# Broadcast Products Technical Bulletin 20-2005-014

SUBJECT: H JITTER DURING NORMAL SCAN

MODEL: ***BVM-D24E1WA***  
***BVM-D24E1WE***  
***BVM-D24E1WU***  
***BVM-D32E1WA***  
***BVM-D32E1WE***  
***BVM-D32E1WU***

**Figure 1**

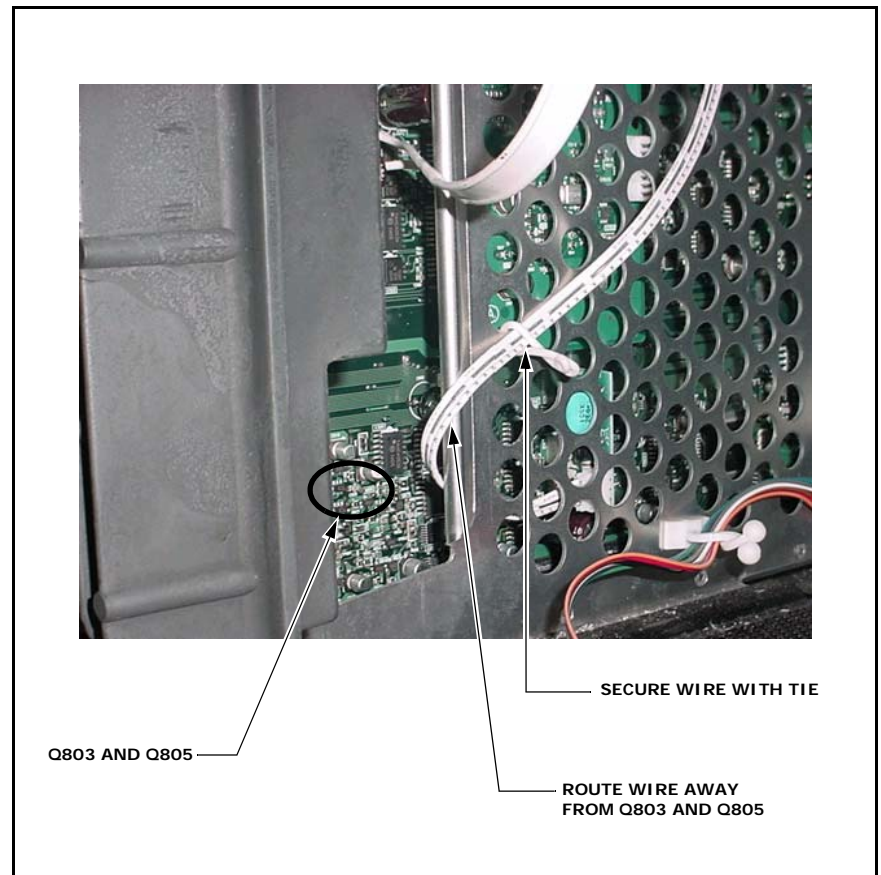
H jitter may occur if the wire connecting the BK2 board to the C board is positioned close to the SYNC\_AGC circuit (Q803, Q805) on the BK board.

1. Route the wire away from Q803 and Q805.
2. Secure the wire with a tie or purse lock.
